**NORTH DAKOTA DEPARTMENT OF TRANSPORTATION
CONTRACT FOR PROCUREMENT**

REQUEST FOR PROPOSAL TITLE: Snow Plow Truck Turnkey Package

REQUEST FOR PROPOSAL NO.: 065-30-19-050

PLOW HEADLAMPS

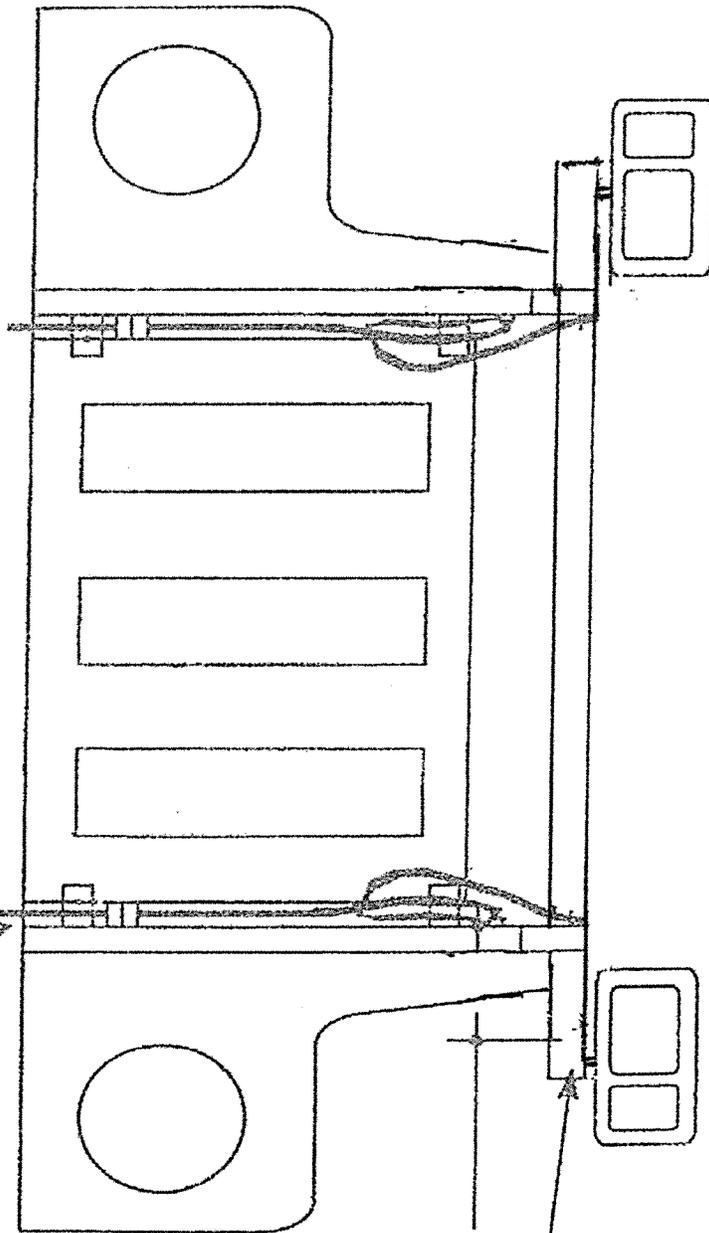
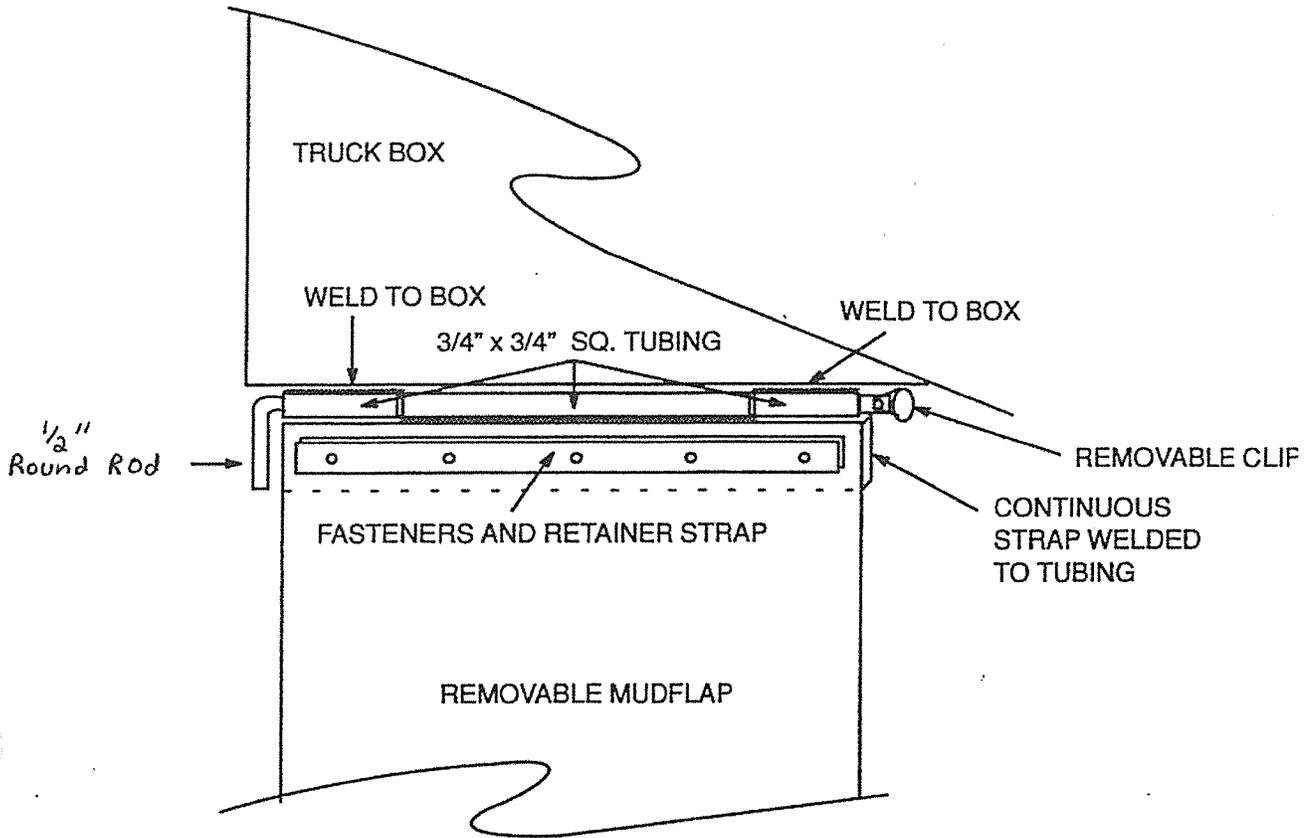
✓ **Question 1)** Plow Lights Item "iv": The specifications call for the mounting brackets to use existing holes in the "Grill". We have a concern that the grill is stationary to the frame and does not move when the hood is to be opened; therefore, it may be necessary to have the plow light mounting frame attached to the hood so that the hood can be opened. This may require us to drill new holes. Would this be acceptable?

✓ **Answer 1)** Reference Specifications page 13, 10 (b) (iv) and page 27, 19 (c) (vi).
Change first sentence to read: 2"x2"x1/4" Aluminum angle to be fastened with bolts to grill/hood.
RFP Specifications is hereby amended.

Fixed bracket to hood to be made
from 2" by 2" aluminum angle
1/4" thick
